Access Compliance Report

Public Rights-of-Way

(Curb Ramps)

Intersection ID: 47124	Main Street: GOLD_WORTHY_CT	Cross Street: EMMONS_LN	Location: SW
ADA ID: D7CF62258999	Ramp Type: BlendTrans1	Initial Pass/Fail: Fail	Overall Compliance: No
Severity Score: 12.5			
Codes/Mitigation Info/Possible Solution		Field Measurements/Component Compliance

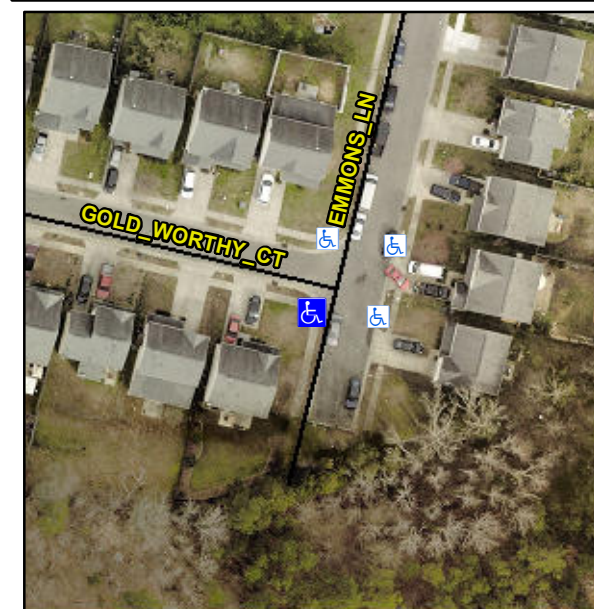
Not Found, R304.5.3

Compliance	Description	Data	Compliance	Description	Data
N/A	Ramp Length (in)	48.0	Yes	BlendTrans Slope (%)	2.6
Yes	Ramp Width (in)	48.0	No	BlendTrans XSlope (%)	5.6
N/A	Flare Type LT	N/A	N/A	Flare Type RT	N/A
N/A	Flare Slope LT (%)	N/A	N/A	Flare Slope RT (%)	N/A
N/A	Flare Traversable LT?	N/A	N/A	Flare Traversable RT?	N/A
N/A	Landing Length (in)	N/A	N/A	DWS Provided?	N/A
N/A	Landing Width (in)	N/A	N/A	DWS Contrast?	N/A
N/A	Landing Slope (%)	N/A	N/A	DWS Length (in)	N/A
N/A	Landing X Slope (%)	N/A	N/A	DWS Full Width?	N/A
N/A	Landing Curb? (Y/N)	N/A	N/A	DWS Offset (in)	N/A
N/A	Shared Landing?	N/A			
N/A	Gutter Ponding?	N/A	N/A	Gutter Slope (%)	N/A
N/A	Gutter Lip Ht (in)	N/A	N/A	Gutter X Slope (%)	N/A
N/A	Painted X Walk1?	No	N/A	Painted X Walk2?	No
	X Walk 1 Direction	To SE		X Walk 2 Direction	To NE
	X Walk 1 Width (in)	N/A		X Walk 2 Width (in)	N/A
	X Walk 1 Slope (%)	3.3		X Walk 2 Slope (%)	3.4
	X Walk 1 X Slope (%)	4.1		X Walk 2 X Slope (%)	1.4

N/A	Ramp inside XWalk1?	N/A	N/A	Ramp inside XWalk2?	N/A
	Road Slope (%)	4.9		Clear Space?	N/A
	Road X Slope (%)	1.4	N/A	Clear Space to XWalk (in)	N/A
N/A	Any Obstructions?	N/A	N/A	Storm Grate/Utility Hazard?	N/A
	Obstruction Type			Storm Grate/Utility Type	
		N/A			N/A
			Yes	Surface Condition? (G/P)	Good
			No	Curb Slope (%)	12.8

Remove & Replace Curb Ramp With Two New Directional Ramps or Equivalent.
